# **Code Analysis and Conditions Assessment Report**

## **Evanston Arts Center**

Prepared for:  
**City of Evanston**

Prepared by:  
**McGuire Iglesias & Associates, Inc.**

**BASEMENT FLOOR PLAN**  
 SCALE: 3/32" = 1'-0"

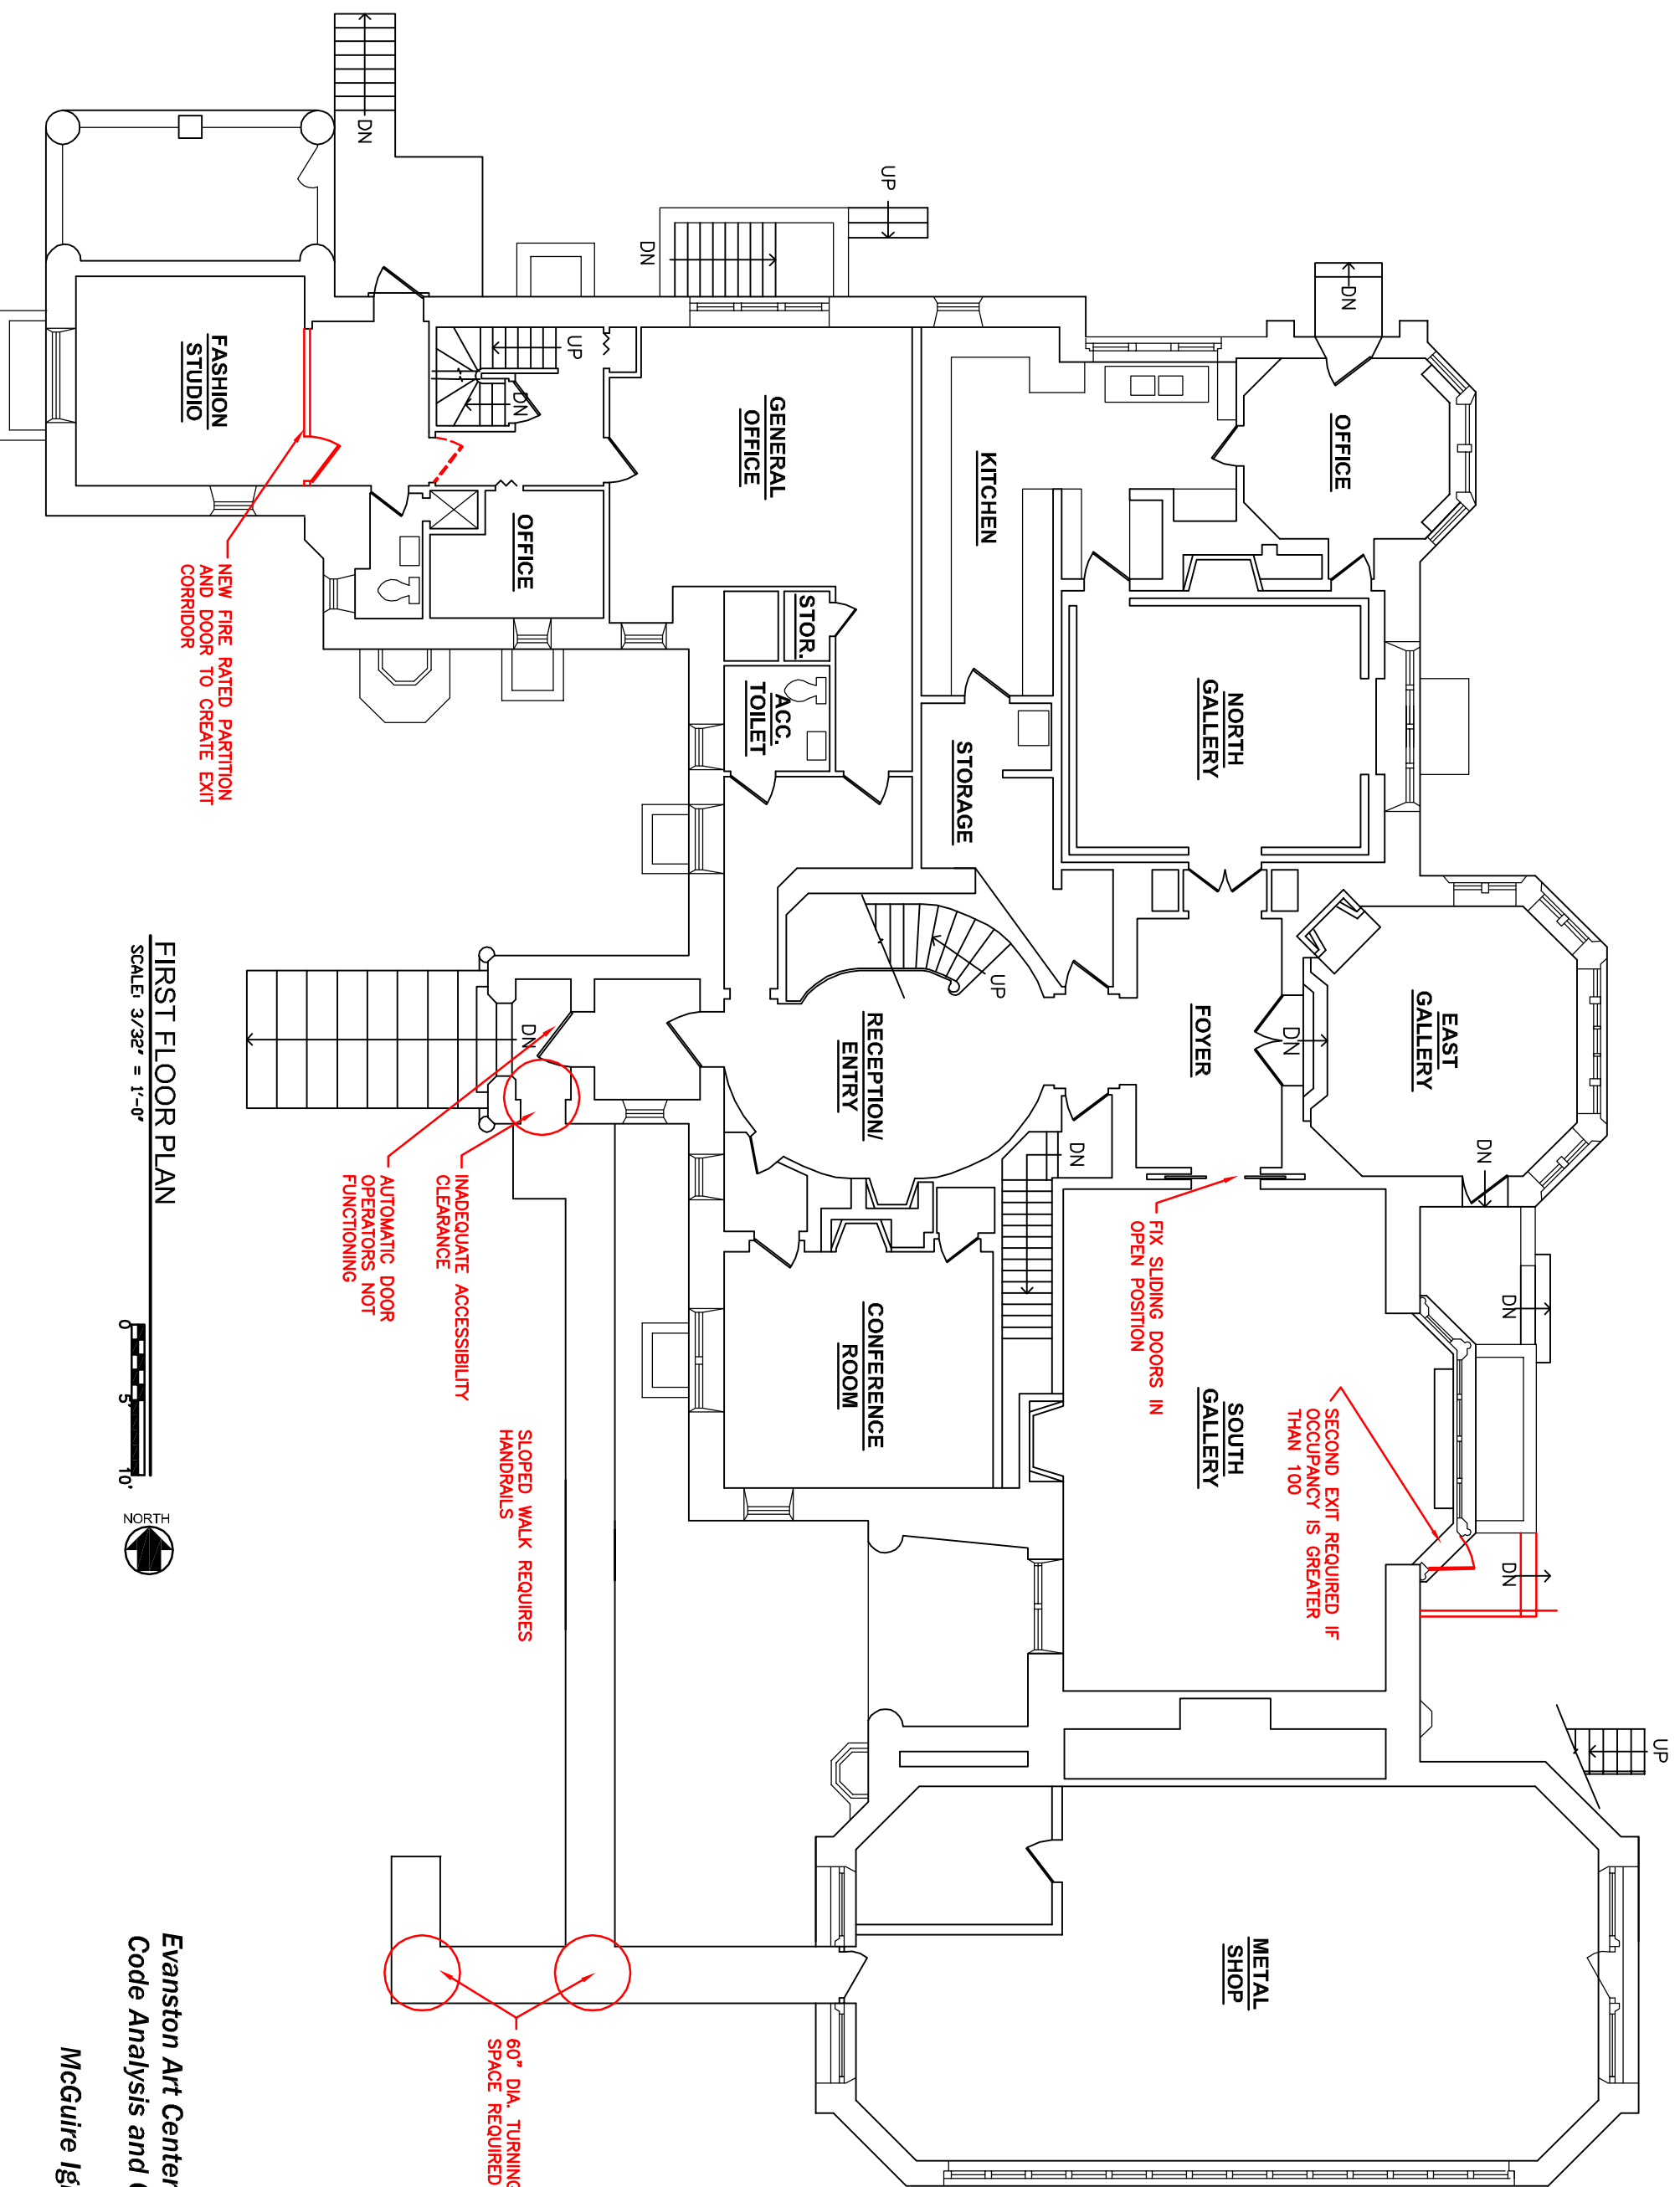
NEW FIRE RATED PARTITION AND DOOR TO CREATE EXIT

INADEQUATE ACCESSIBILITY CLEARANCE

SLOPED WALK REQUIRES HANDBALLS

AUTOMATIC DOOR OPERATORS NOT FUNCTIONING

FIX SLIDING DOORS IN OPEN POSITION

SECOND EXIT REQUIRED IF OCCUPANCY IS GREATER THAN 100

60" DIA. TURNING SPACE REQUIRED
